# Spartan Fire, LLC

Campaign Service Bulletin  
CSB23-260-003

**CONDITION:** Changes based on new product testing to improve steering geometry and reliability.

**CORRECTION:** Replace steering assist cylinder bracket, officer side steering arm, assist cylinder steering hose, install frame rail reinforcement, and relocate air dryer and governor.

**Figure 3.1**

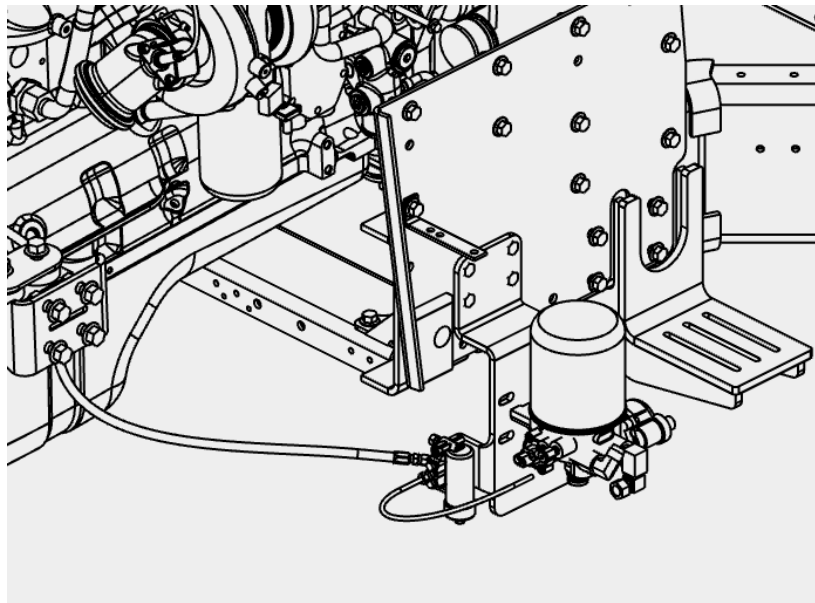
- 1) Remove air dryer and bracket from right side frame rail. *See Figure 3.1.*
  - a. Locate the air dryer on right side frame rail in front of the steer tire.
  - b. Remove air lines and electrical connections.
  - c. Remove air governor from bracket.
  - d. Remove air dryer from bracket.
  - e. Remove air dryer bracket from frame and discard bracket.

**Figure 4.1**

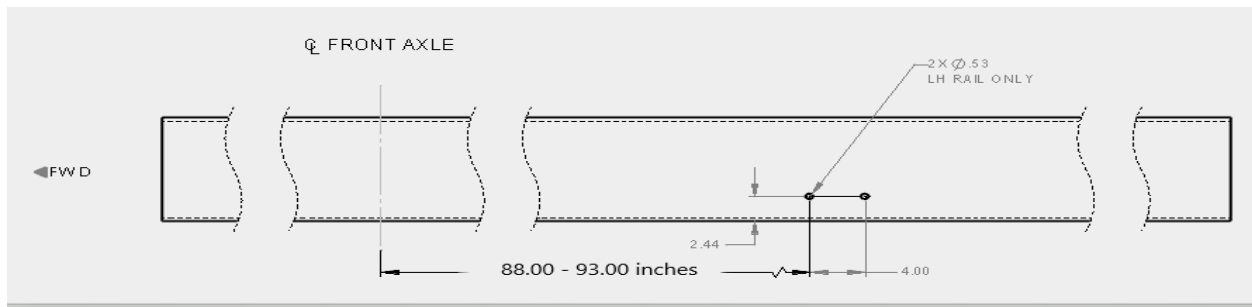
- 2) Install air dryer and governor on left side frame rail. *(See Figure 4.2)*
  - a. Drill two holes as shown in Figure 4.1. The recommendation is to locate the holes 88 -93 inches from the centerline of the front axle to the forward most

- hole, but ultimately the new brackets and air dryer should be used as a template to mark the holes to ensure proper clearance with other items in the region.
- Mount new upper air dryer bracket (3405-MM5-002) to left side frame.
  - Fasten lower air dryer bracket (3406-MM5-002) to the upper bracket.
  - Mount air dryer to left side brackets.
  - Torque all ½ inch fasteners to 75 ft. lbs

**Figure 5.1**

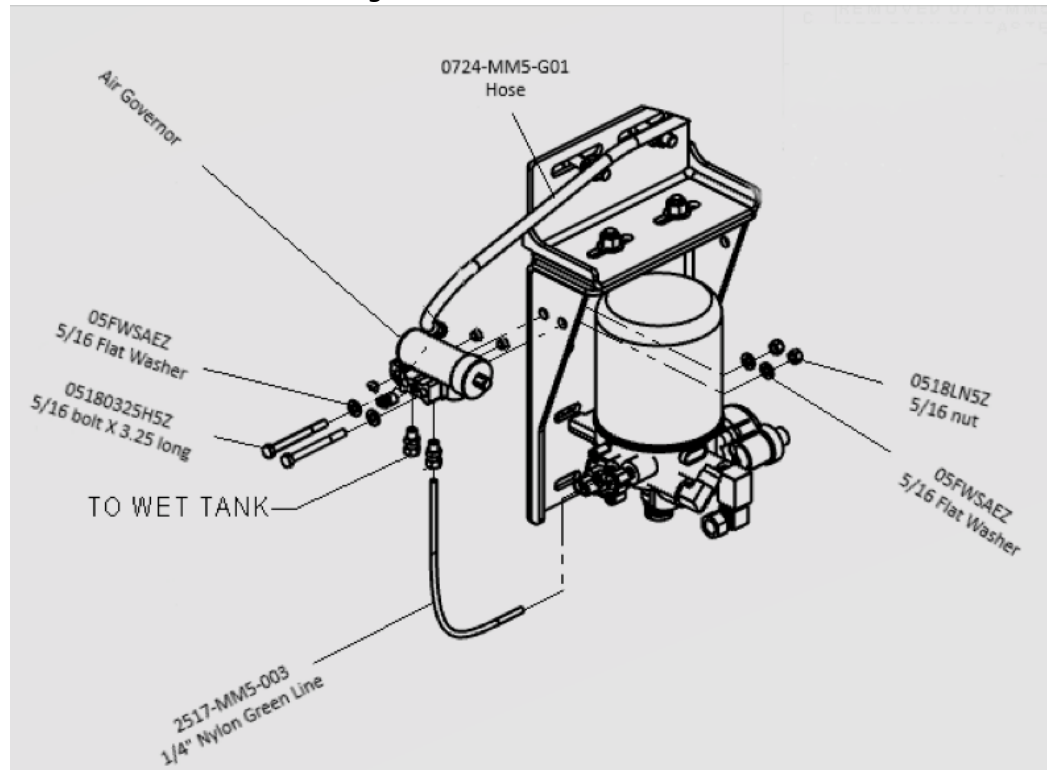
- f. Take the air governor that was removed in step 1c and install it on the new driver's side bracket. See Figure 5.1

**Figure 6.1**

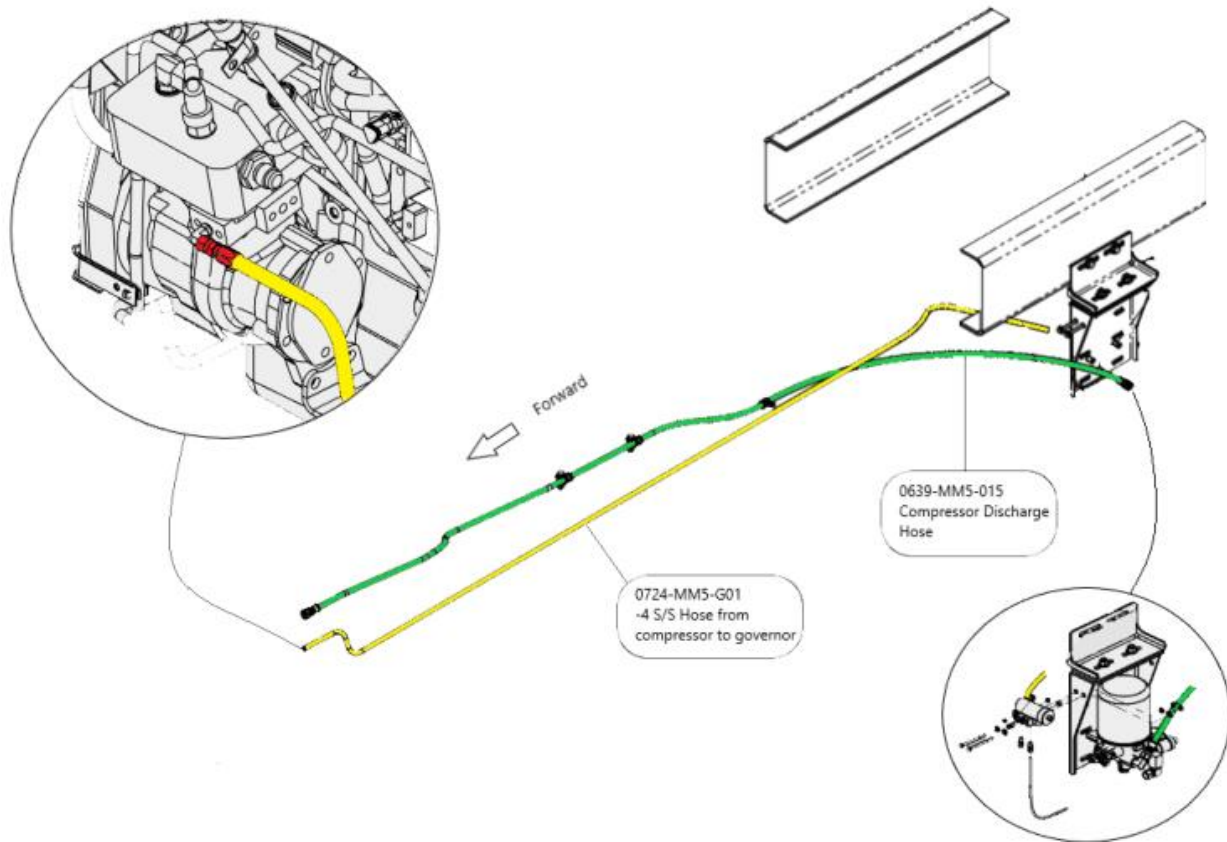
- a. Reroute electrical connector from right side frame rail location to left side frame location.
- b. Reconnect electrical connector to air dryer now located on the left side frame rail.
- c. Install new compressor discharge line (pn 0639-MM5-015) and governor line (pn 0724-MM5-G01).
- d. Ensure compressor discharge line is routed clear of all hoses, harnesses, etc. to prevent chafing.
- e. The compressor discharge line must be mounted on a downward slope from the compressor to the dryer.

See Figure 6.1

**Figure 7.1**

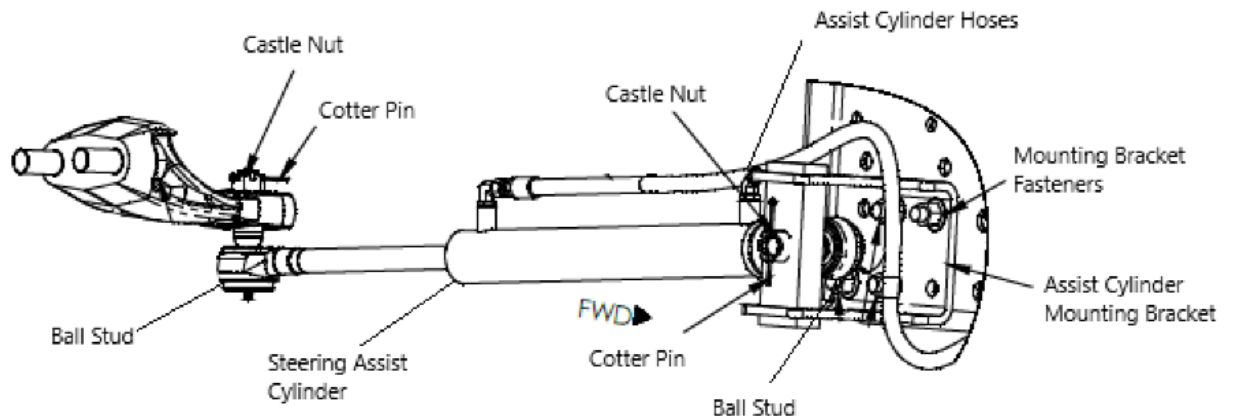
- 3) Remove steering assist cylinder and mounting bracket.
  - a. Remove assist cylinder hydraulic hoses. Label hose ends for proper reinstallation.
  - b. Remove cotter pins from each assist cylinder stud.
  - c. Loosen the castle nuts 4-5 turns.
  - d. Use appropriate puller tool to unseat the ball stud from the mount.
  - e. Once loosened from the mount, completely remove the castle nuts.
  - f. Remove the assist cylinder.
  - g. Remove the steering assist cylinder mounting bracket fasteners.
  - h. Discard steering assist cylinder mounting bracket.

*(See Figure 7.1)*

**Figure 7.2**

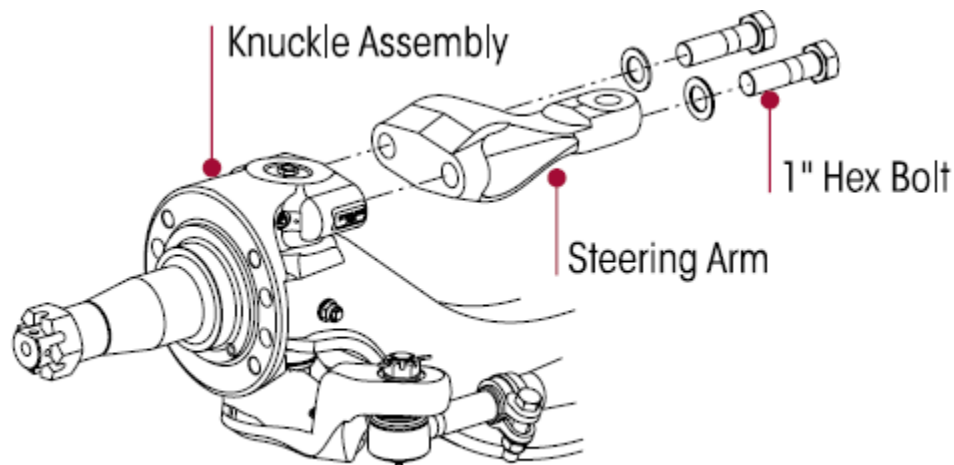
- a. Remove the two steering arm to knuckle hex bolts that hold the steering arm to the knuckle.
- b. Remove the steering arm from the knuckle. Gently tap the outside of the steering arm with a leather or plastic mallet if steering arm does not separate by hand.

(See Figure 7.2)

**Figure 8.1**

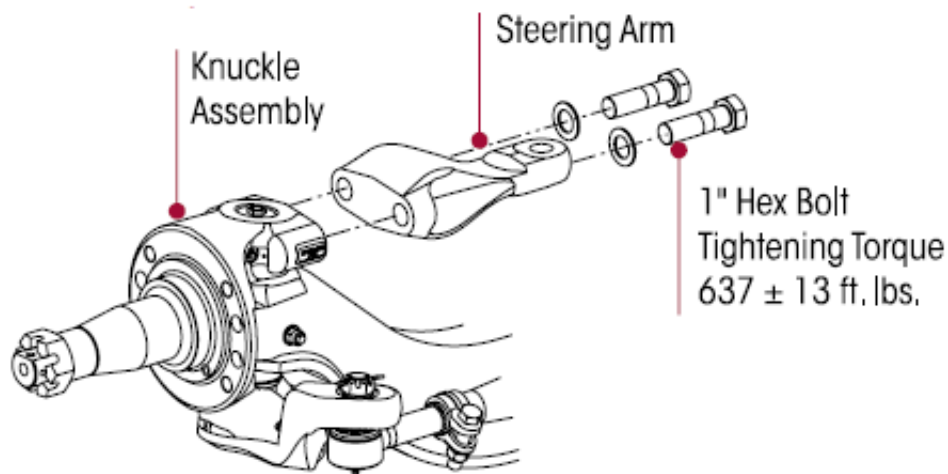
- a. Use a tap to remove old thread-locker compound from the internal threads in the steering knuckle.
- b. Use new steering arm hex bolts (pn: 30550-027) and new washers (pn: 22962-051). Coat at least half of the thread area with Loctite 680 adhesive.
- c. Insert the hex bolts through the new steering arm. Hand start the bolts into the knuckle assembly.
- d. Tighten the steering arm hex bolts to  $637 \pm 13$  foot pounds torque.

(See Figure 8.1)

**Figure 9.1**

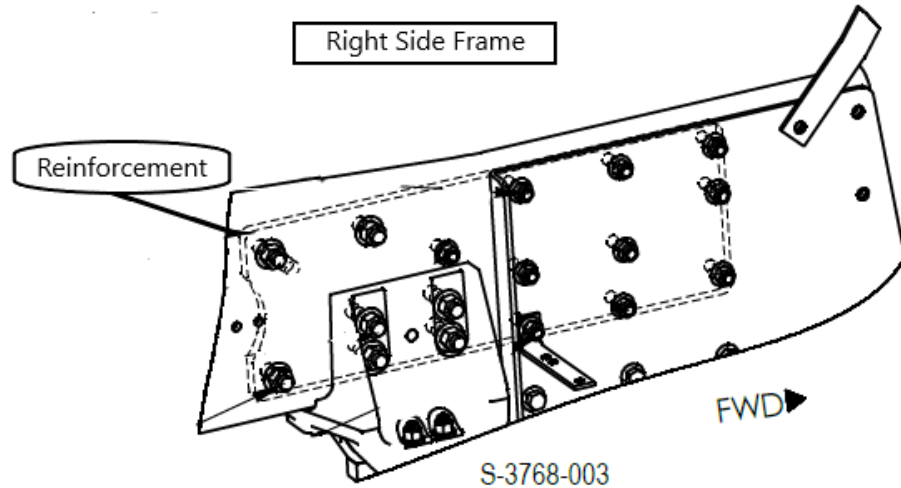
- 6) Install right side frame rail reinforcement.
  - a. Support front engine crossmember and splay rail.
  - b. Remove the fasteners shown in Figure 9.1 in preparation for the installation of the reinforcement.

**Figure 9.2**

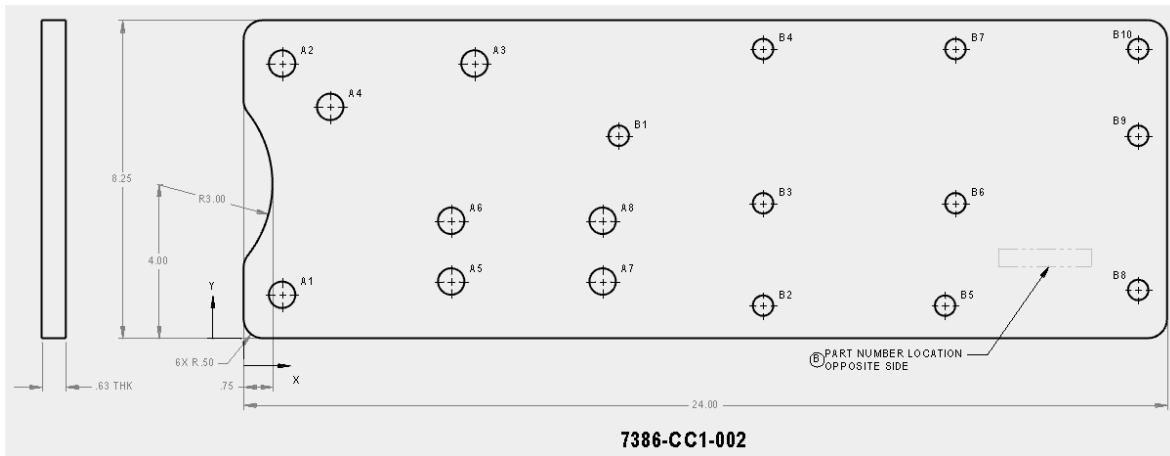
- c. Verify reinforcement plate is correct part number (7386-CC1-002) before installation. (See part number location in Figure 9.2)

**Figure 10.1**

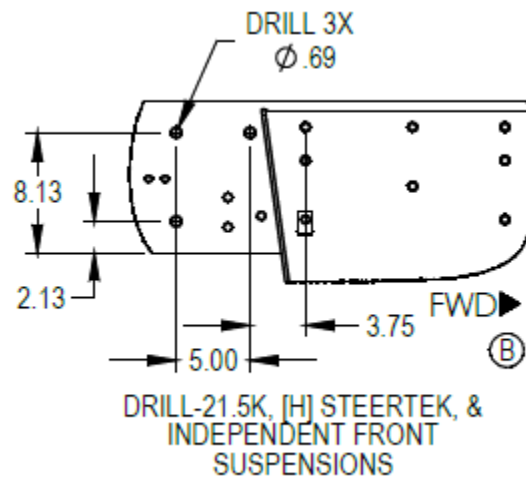
- d. Prepare frame rail for reinforcement by drilling three holes indicated in figure 10.1

**Figure 10.2**

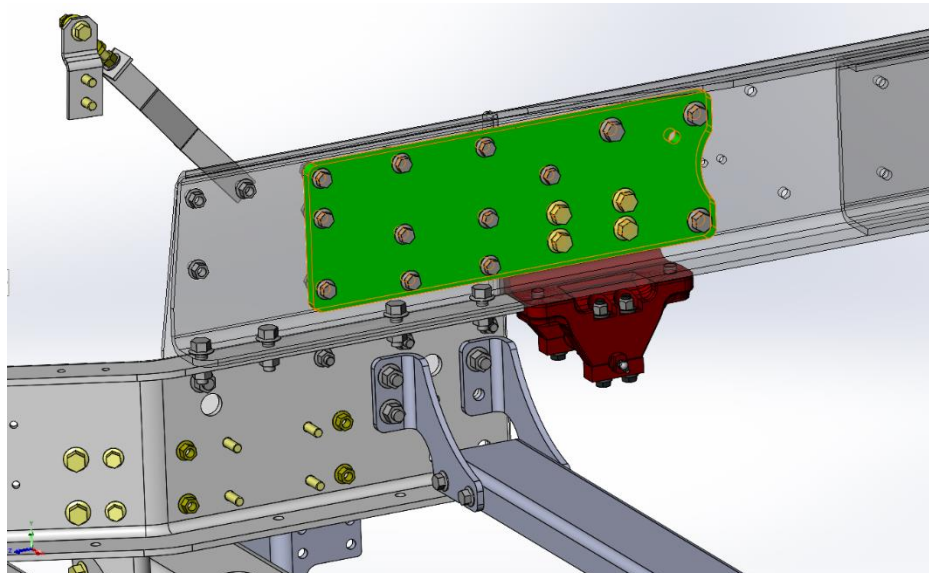
- e. Install reinforcement inside inner frame rail as shown in Figure 10.2

**Figure 11.1**

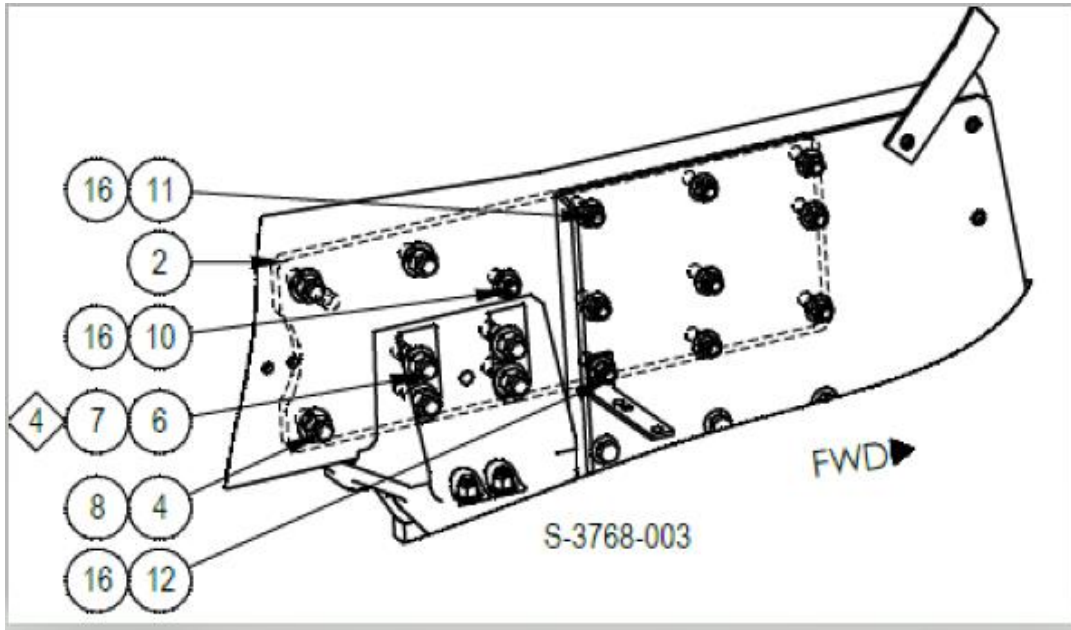
- f. Install fasteners with nuts on the outside of frame rail (see Figure 11.1) and torque nut side to torque spec listed in table 11.2.

**Figure 12.1**

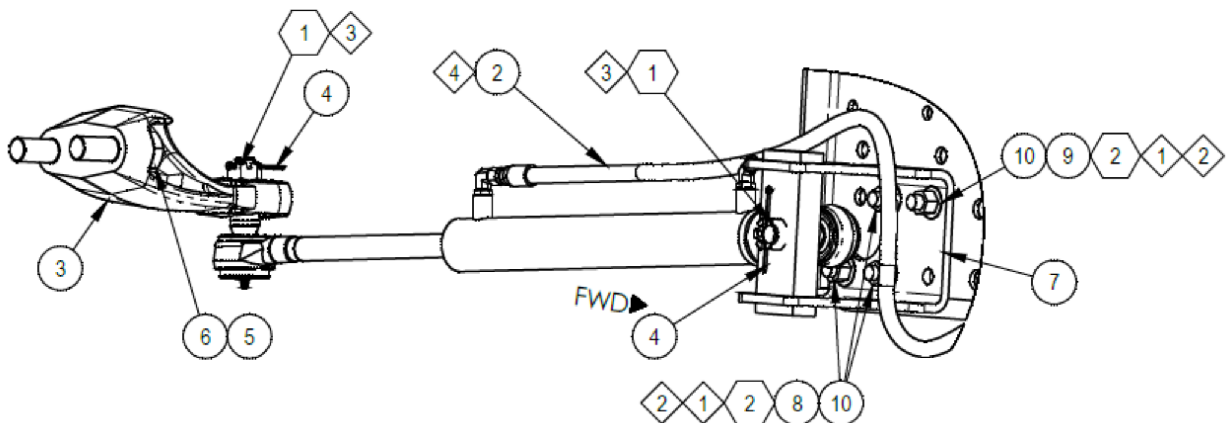
7) Reinstall assist cylinder and new bracket. (See Figure 12.1)

- a. Install new steering assist cylinder bracket part number 3161-KK1-001 (Item 7) using new bolts (item 8-9) and new nuts (item 10). Install bolts hand tight. Do not torque until after the steering assist cylinder is installed.  
*Note: Bolt item 9 is longer and must be installed in the location noted in Figure 12.1.*

- c. Torque each castle nut to 145 ft lbs. If castle nut slot does not align with the cotter pin hole in the ball stud initially, tighten nut slightly to align the slot with the hole. **Do not loosen to align the slot to the hole.**

- d. Install cotter pins through castle nut and ball stud and bend cotter pins over.
- e. Torque the new 5/8" diameter bolts in new steering assist cylinder bracket to 201 ft lbs.  
*See Figure 12.1 and Table 13.1*

**Figure 13.2**

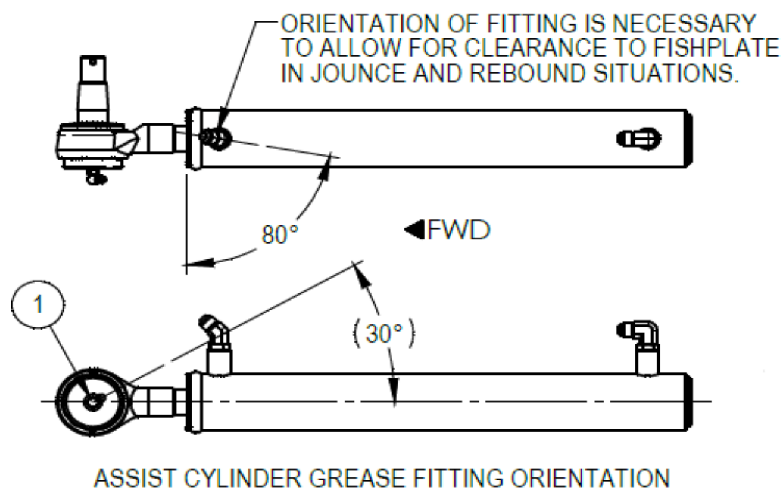
- f. Verify correct orientation of fittings on the assist cylinder before reconnecting hoses. See Figure 13.2

**Figure 14.1**

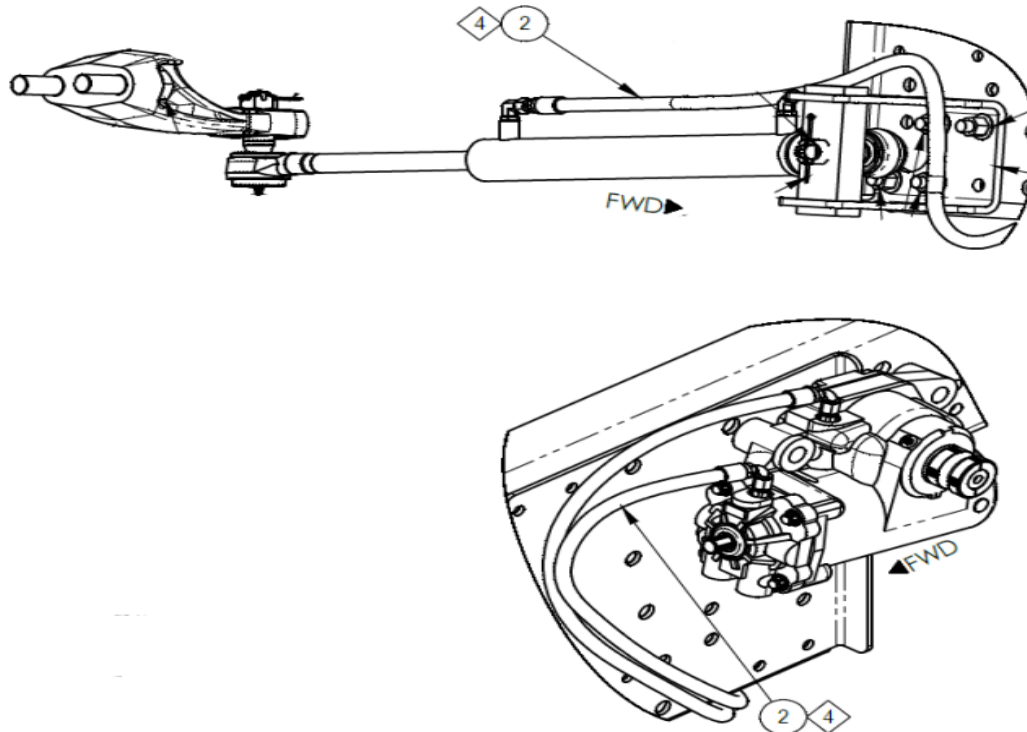
- g. Reconnect hydraulic hoses to assist cylinder, noting proper port orientation per labels installed in step 3a. Replace hose plumbed to rear assist port with longer hose to improve routing (06W-06JA06JB108). Also, refer to *Figure 14.1* below for proper hose orientation.
